Road Safety Audit Review

Town:	St Albans Town	Date Reviewed:	May 31 2016 2017
Route:	VT 36 @ Rugg Road and Kyle Rd (private road)	Mile points:	VT 36 MM 4.84

The location of this RSAR is the intersection of VT 36, Rugg Road and Kyle Road in St Albans. This intersection is located at mile point 4.84 on VT 36.

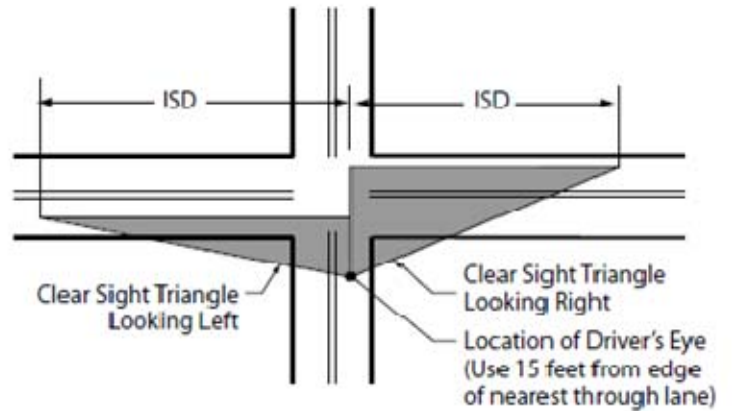
Concern: Children Have to Cross VT 36 in Front of the School Bus

Children residing on Kyle Road are being dropped off on the south side of VT 36 at Rugg Road. Children then have to cross VT 36 to get to Kyle Road. Because of the horizontal curve and of the vertical crest, the bus is not readily visible.

Safety Enhancements:

Install a school bus stop ahead sign eastbound on VT 36 before the crest of the curve.

Looking West from Kyle Road. View is from driver's position

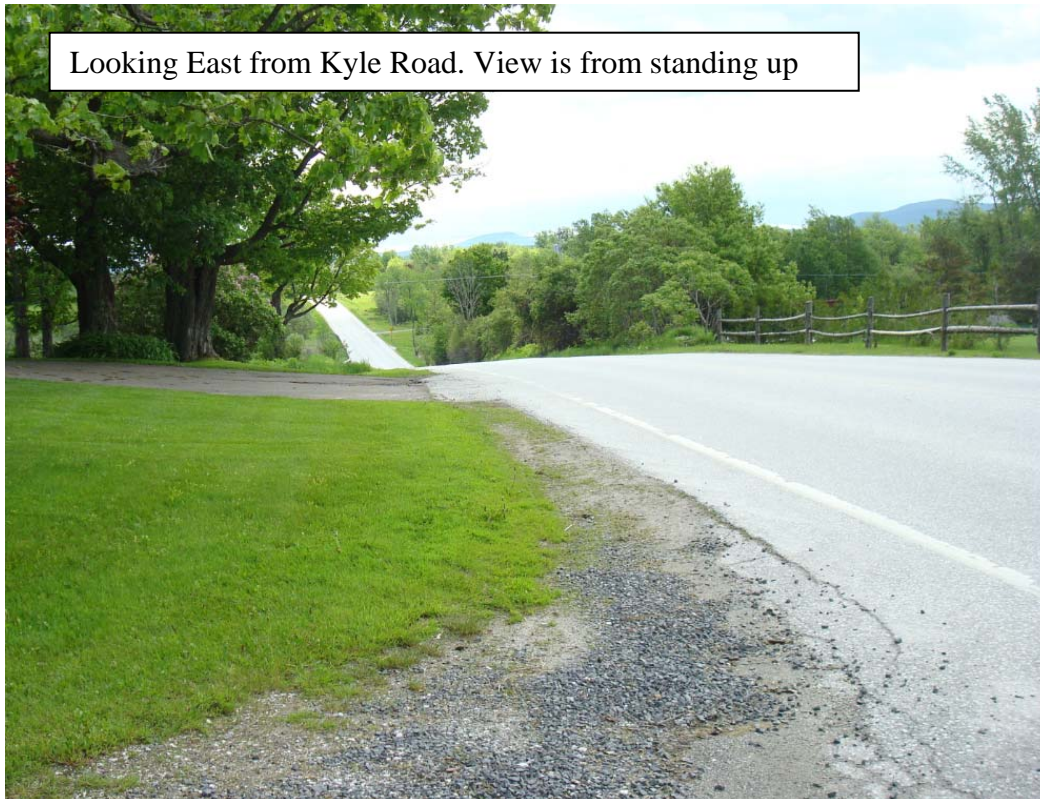
Concern: Corner Sight Distance Issue, Northwest Quadrant (Kyle Rd)

The corner sight distance (ISD) for a motorist that is stopped on Kyle Road and who is looking to the right (west), towards ST Albans, is inadequate and below standards. The recommended corner sight distance for the actual posted speed limit of 50 mph is 555 feet.

The available corner sight distance was measured to be 273 feet.

The embankment on the north side of VT 36 and the horizontal/vertical curve combination west of the intersection contribute to this issue.

Safety Enhancements:

Improve the advance curve signage as mentioned previously by relocating the signs closer to the intersection and by replacing them with new Type IX sheeting signs.

Evaluate what gain in corner sight distance could be achieved to the west by cutting back the bank on the north side of the road.

Install a dynamic warning system (like the one at Russell Road in Sheldon) that would inform motorists on Kyle Road that a vehicle is approaching from the right. Alternatively, install a

system west of the intersection that would warn traffic traveling eastbound on VT 36 that a vehicle is stopped on Kyle Road.
